SLR Project No.: 501.V00727.00008

Client Reference No.: Knockanarragh Wind Farm

An Bord Pleanála No.: 319448-24

**RE: Response to third party observations.**

**Figure 1: Peat Bog Land Cover Map**

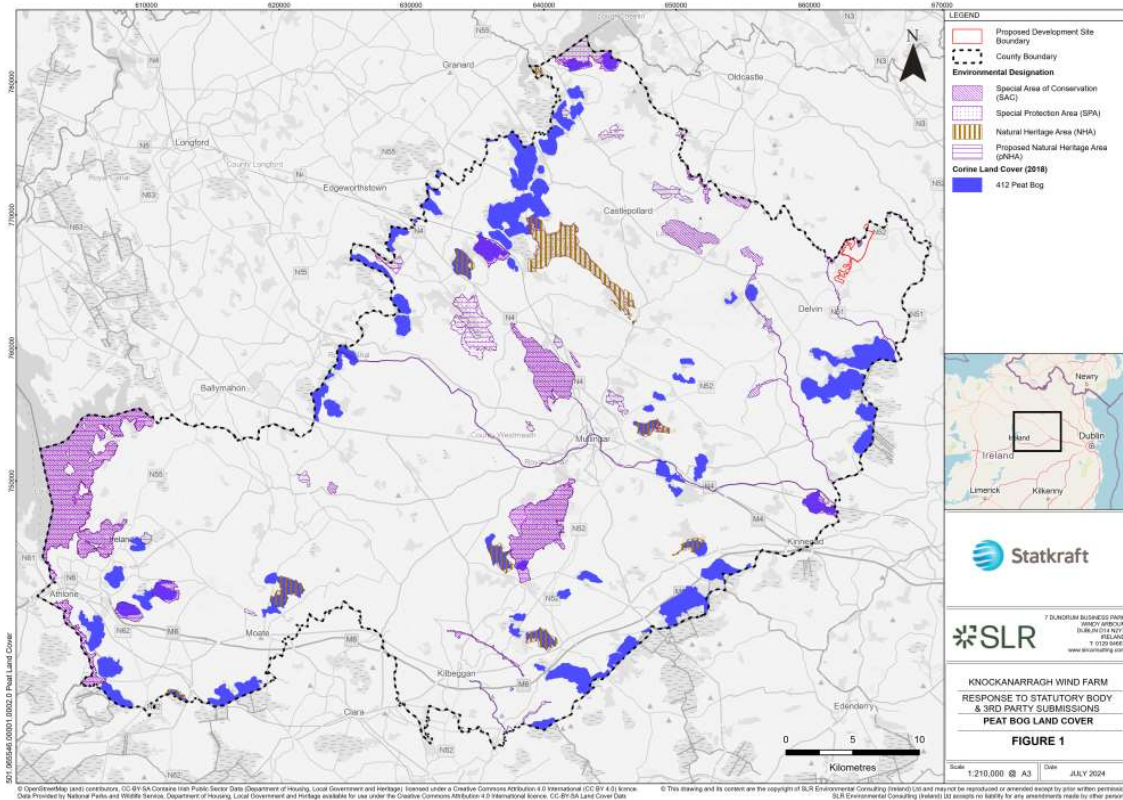
In planning for the delivery of Target Power Capacity (MW) allocations as will be required by National Policy Objective 75 and 76, it is clear that strict adherence to this policy objective is no longer practical. Of the 11,350 hectares of peat bog in Westmeath only 9,232 ha are left unconstrained by Natural Heritage Areas, Special Protection Areas and Special Areas of Conservation designations, see **Figure 1** below. If a 720m housing buffer is applied in addition to these constraints, there is only 5,167ha available for wind farm development in these areas which represents only 2.8% of the County Westmeath area. This is not to mention the further significant reduction in this area due to other constraints as well as the significant carbon emissions balance issues arising from the development of such sites.

While the RSES calls for a focus on publicly owned peat extraction areas as suitable areas for renewable energy developments, it does not call for them to be strictly directed to peatlands. It could be suggested that Westmeath County Council’s Policy Objective CPO 10.145 is overly prescriptive and does not accord with national policy.
